VILLAGE OF MONROE

Workshop
July 13, 2026

Site Plan Review – Country Inn 236 High Street (Rest Haven)

Subject: Proposed Restaurant/event space, 238 High Street

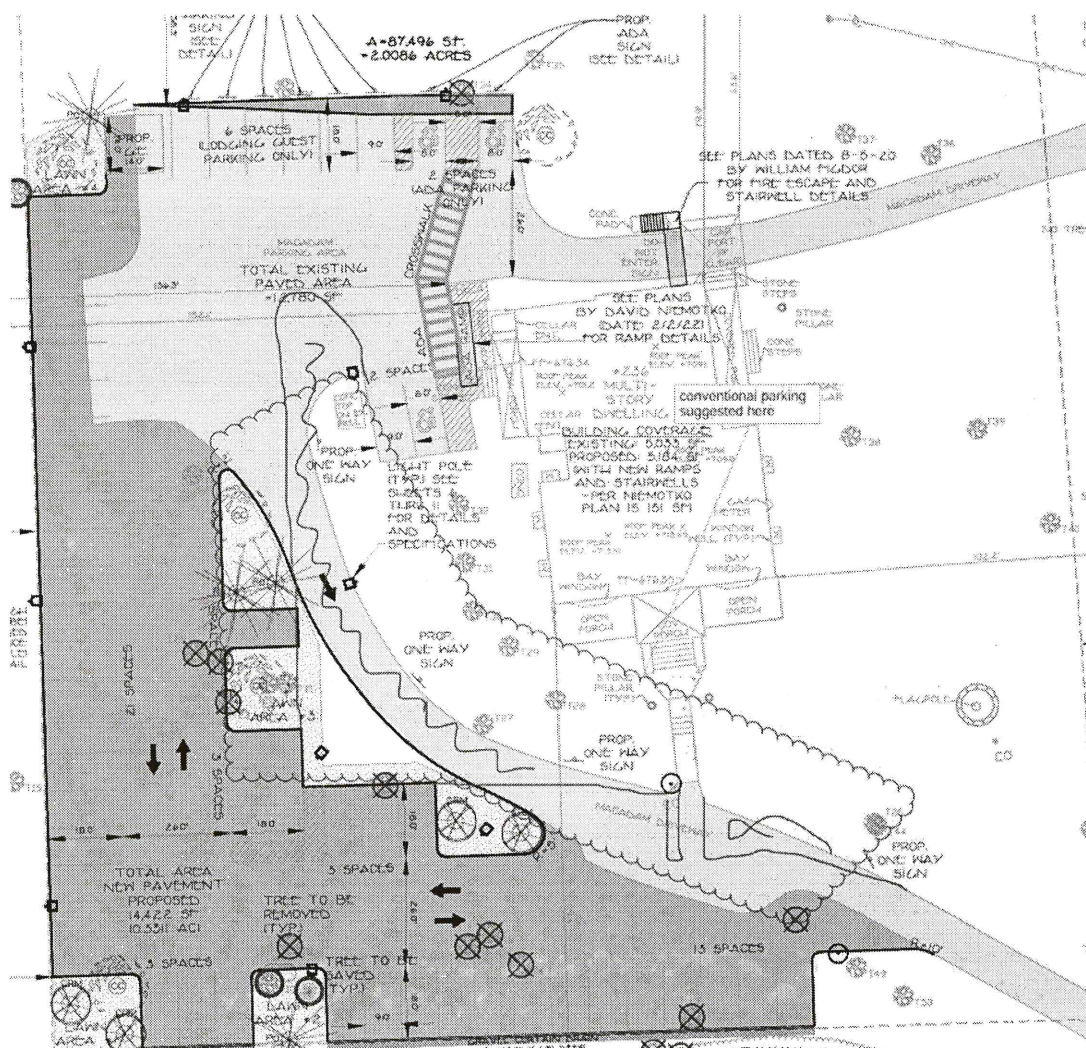
ITE Code 930 provides parking data for a “Fast Casual Restaurant”, described as “a sit-down restaurant with no (or very limited) wait staff or table service. A customer typically orders off a menu board, pays for food before the food is prepared, and seats themselves. The menu generally contains higher-quality, made-to-order food items with fewer frozen or processed ingredients than at a fast-food restaurant. Most patrons eat their meal within the restaurant, but a significant proportion of the restaurant sales can be carry-out orders. A fast casual restaurant typically serves lunch and dinner; some serve breakfast. A typical duration of stay for an eat-in customer is 40 minutes or less.”

ITE Code 931 provides parking data for a “Fine Dining Restaurant”, described as “a full-service eating establishment with a typical duration of stay of at least 1 hour. A fine dining restaurant generally does not serve breakfast; some do not serve lunch; all serve dinner. This type of restaurant often requests and sometimes requires a reservation and is generally not part of a chain. A patron commonly waits to be seated, is served by wait staff, orders from a menu and pays after the meal. Some of the study sites have lounge or bar facilities (serving alcoholic beverages), but meal service is the primary draw to the restaurant”.

ITE Code 932 provides parking data for a “High-turnover (sit-down) Restaurant”, described as “a full-service eating establishment with a typical duration of stay of 60 minutes or less. This type of restaurant is usually moderately priced, frequently belongs to a restaurant chain, and is commonly referred to as casual dining. Generally, these restaurants serve lunch and dinner; they may also be open for breakfast and are sometimes open 24 hours a day. These restaurants typically do not accept reservations. A patron commonly waits to be seated, is served by wait staff, orders from a menu, and pays after the meal. Some facilities offer carry-out for a small proportion of their customers. Some facilities within this land use may also contain a bar area for serving food and alcoholic drinks.”

The Applicant should indicate which category the proposed restaurant will fall into, then provide a calculation (based on the number of gross square feet proposed for restaurant use, as well as the proposed number of seats) indicating how many parking spaces would be required.
